Date: 31 March 2022

From: Chloe Morris
Building Cadet

Variation Description – Perforated Ceilings

DA ACOUSTIC REPORT

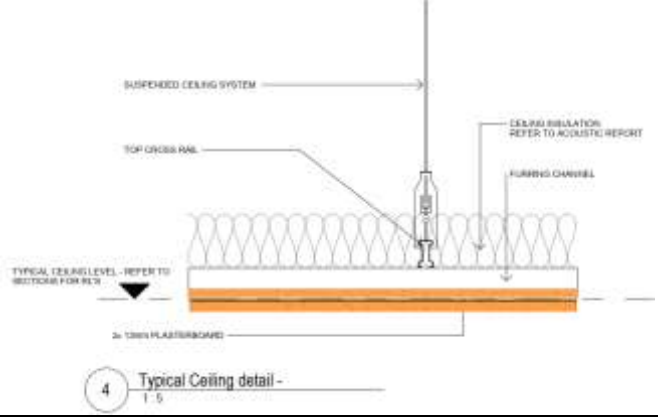
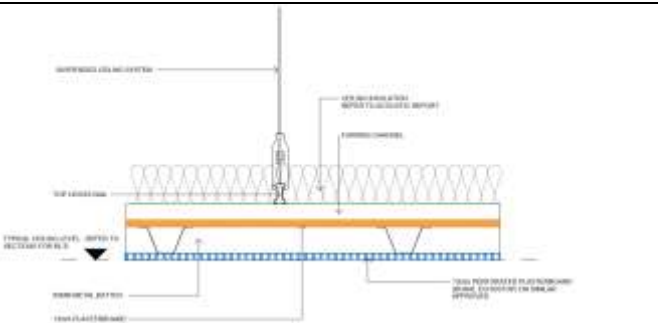
DA Acoustic Report nominates 2x layers of fired rated plasterboard, flush set, with insulation over. This acoustic report was not included in the contract documents, which relied on the Architect's inclusion in their design documents, as design investigations were carried out pre-contact on the extent of acoustic treatment. Extracts below:

- **Ceiling/roof** – Construct the ceiling from 2 layers of 13mm fire rated plasterboard mounted on a resilient mounts below the purlins or resiliently suspended with either Autex ASB-5 or 75mm thick Glasswool Insulation (minimum density of 11kg/m³) in the resulting cavity. Ensure the plasterboard ceiling uses a set joint when connecting to wall sheet. If movement is an issue, allow a gap between the wall and ceiling plasterboard and seal using a suitable polyurethane sealant to seal the junction to full depth of the plasterboard. To cover the joint use a cornice at the wall and ceiling junction.

To upgrade from the original tender allowance to the current perforated ceiling system required the following changes:

Tender / Acoustic Report @ \$126/m² 75mm Glasswool Insulation Suspended concealed grid ceiling frame 13mm fire rated plasterboard 13mm fire rated plasterboard Paint	
Revised Perforated Ceiling @ \$172/m² 75mm Glasswool Insulation Suspended concealed grid ceiling frame 13mm RE plasterboard 50mm top-hat battens Scrim acoustic felt barrier 12mm Echostop Plasterboard Paint
